SPD1000X Over Current Protection (OCP) function added in Firmware Revision 2.1.1.9

March 16, 2022

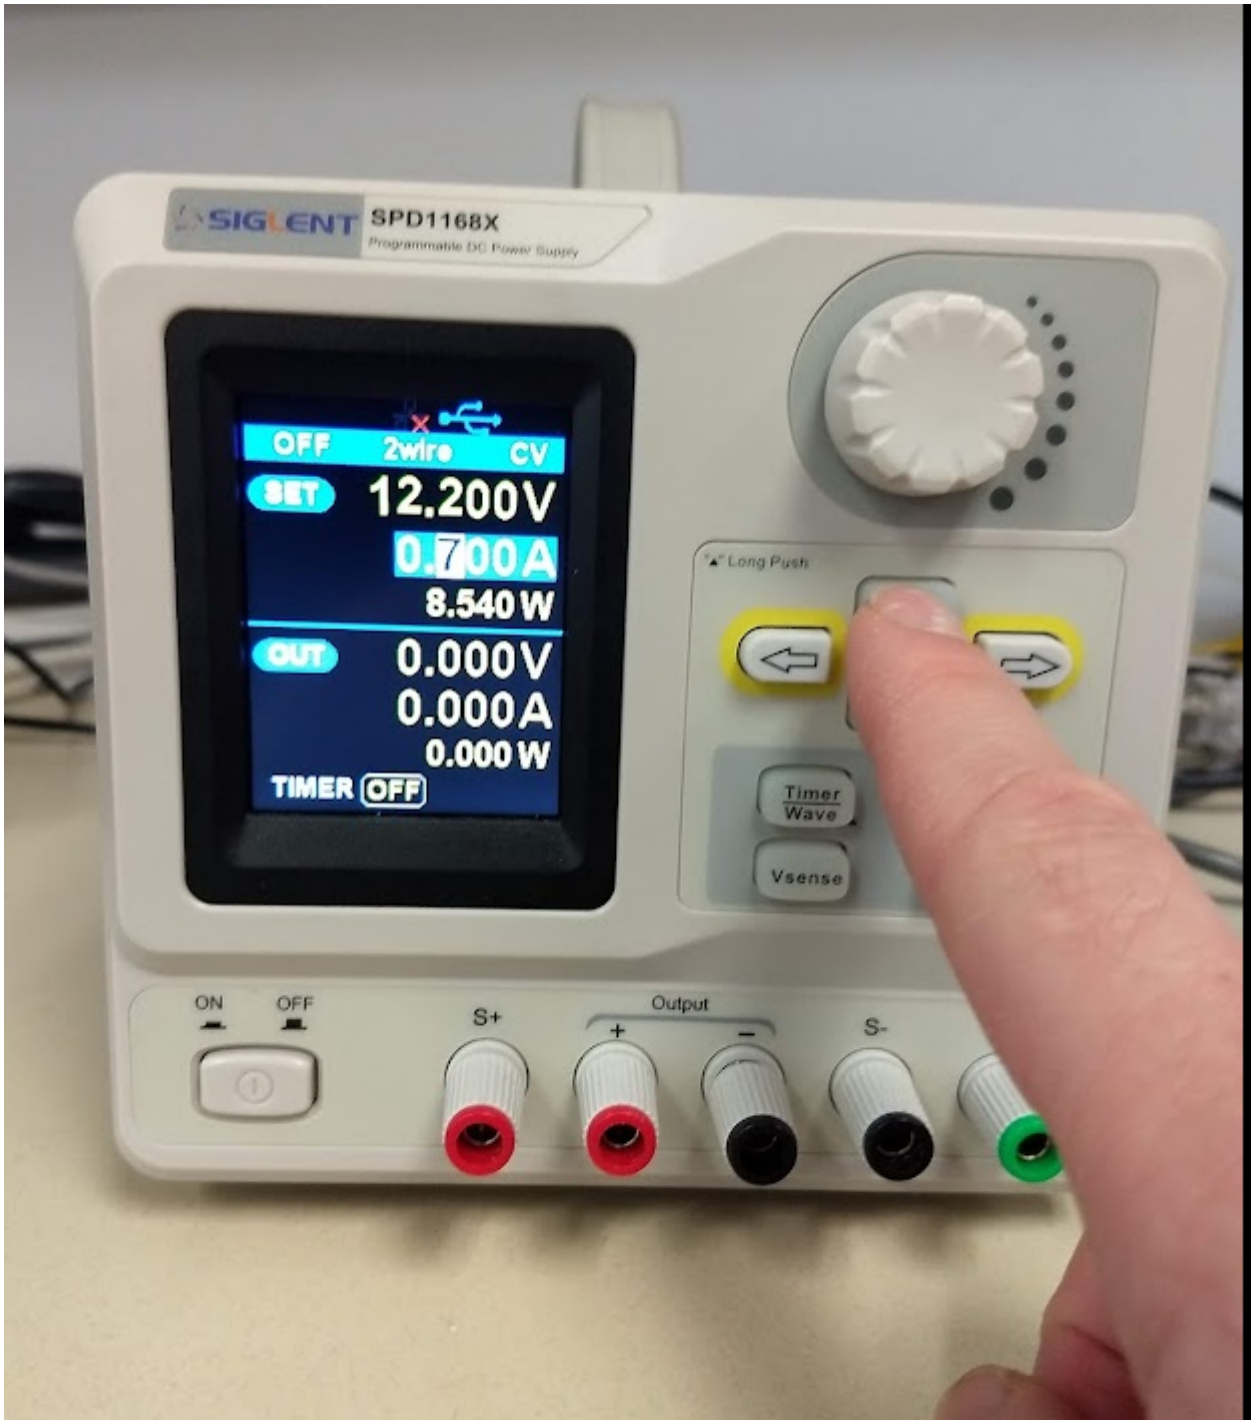
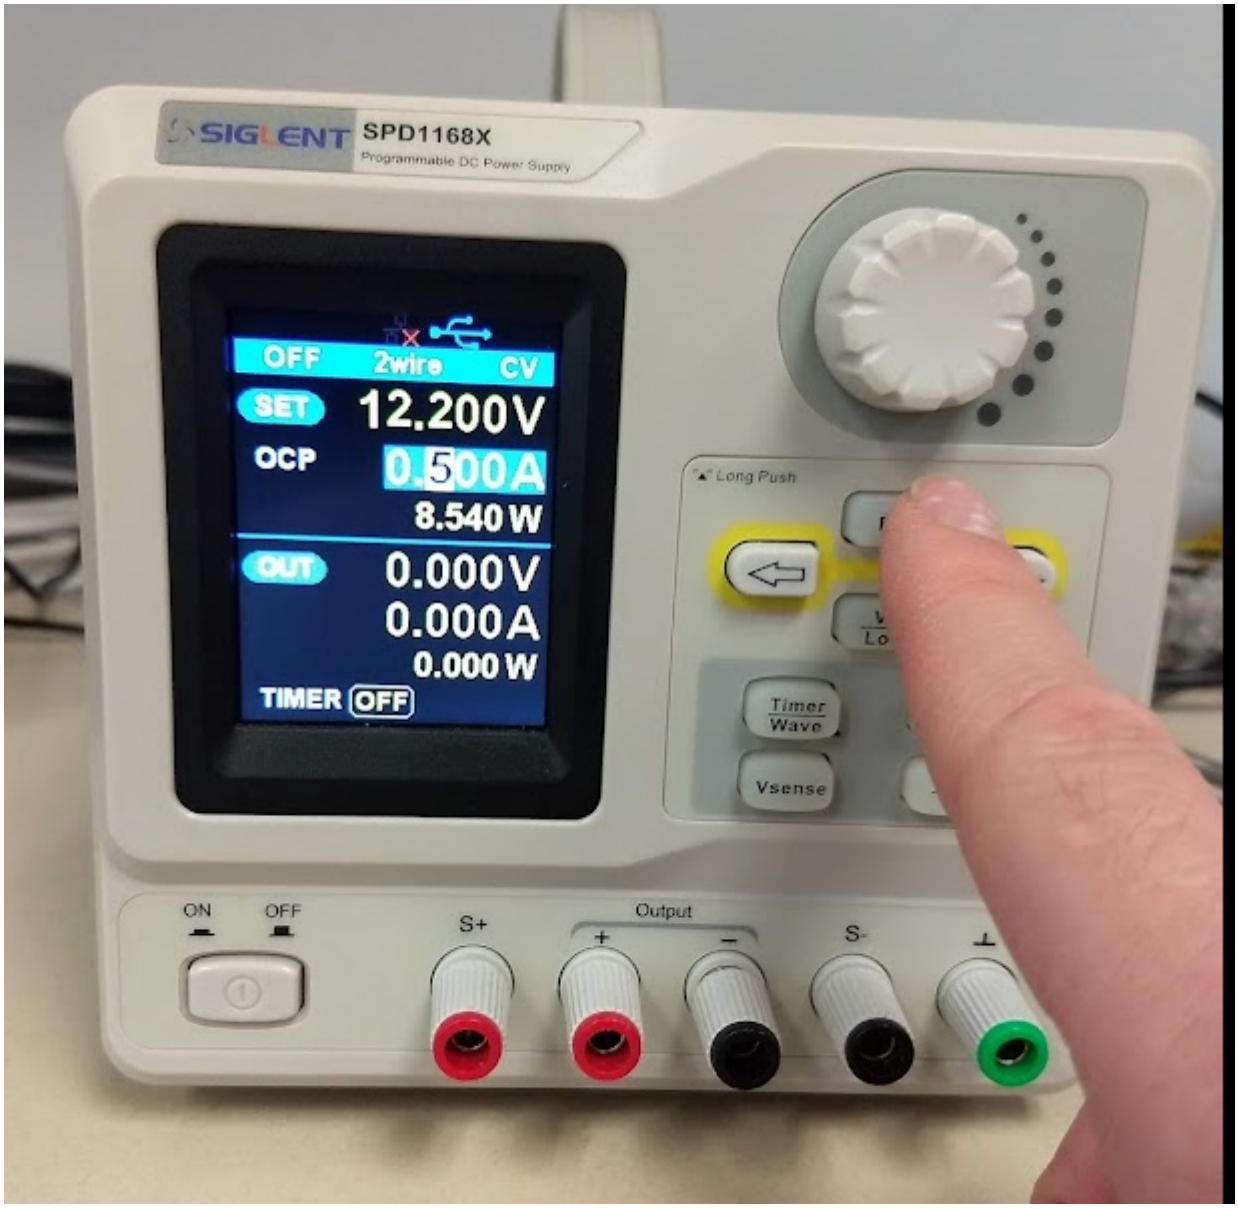
Over Current Protection (OCP) has been added to the SIGLENT SPD1000X series of single-channel power supplies with the SPD version 2.1.1.9

The OCP function quickly disables the output when the current draw from the supply surpasses the set limit current.

1. Update the firmware
2. Set the OCP value by pressing and holding the FINE button on the front panel. After a few seconds, the OCP label will appear:
